**RE: 815 Roger Griffiths Avenue
Urban Design Brief**

1.0 Response to Urban Design Directions

Option 1

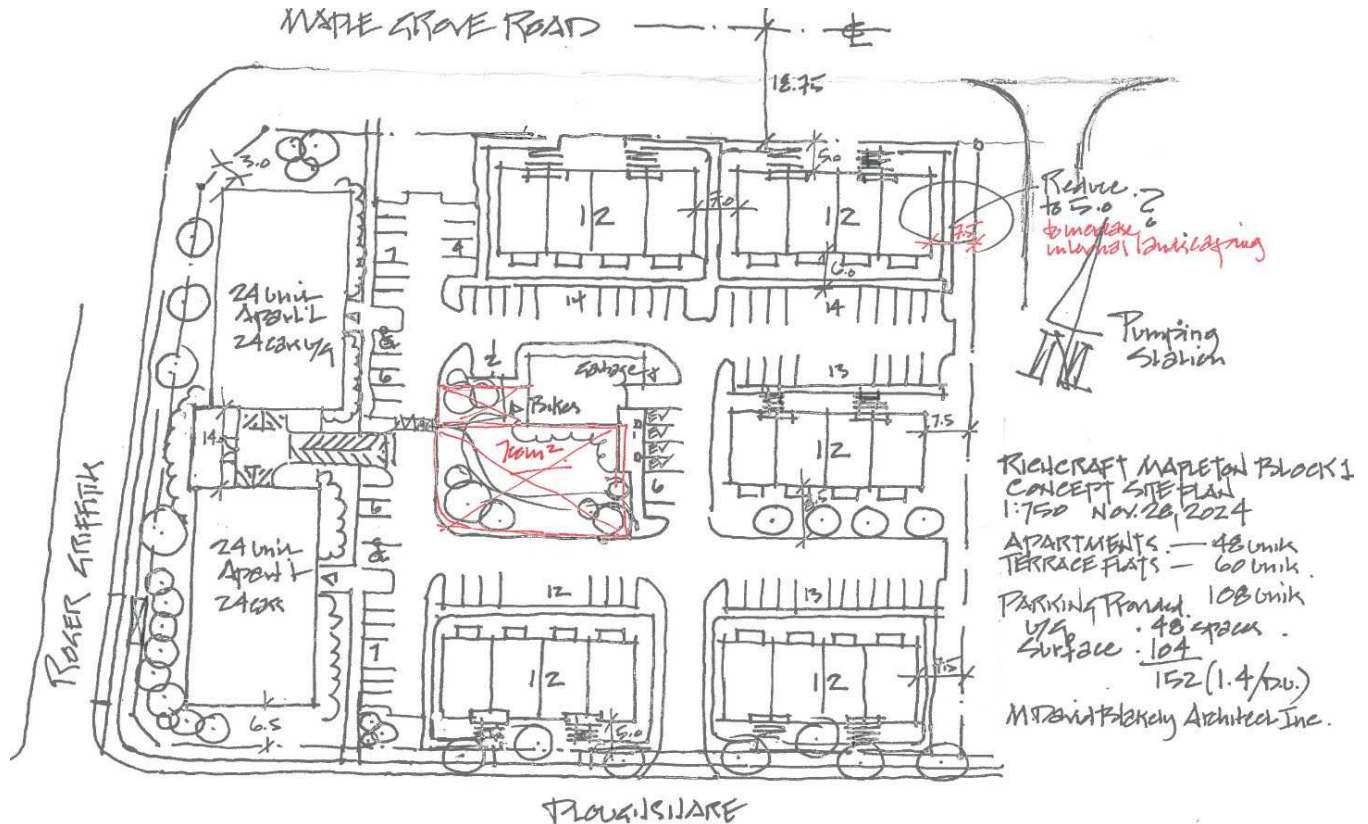
Further to the direction of City of Ottawa Urban Design Staff, examples of alternative site plan options are provided below.

Option 1 advances a concept plan for a single lot development prior to the decision to sever for a distinction between typology as well as rental and condominium. The currently proposed site plan reduces the scale of internal vehicle circulation by fully separating the accesses and locates the amenity area in an area that is more insulated from vehicles.
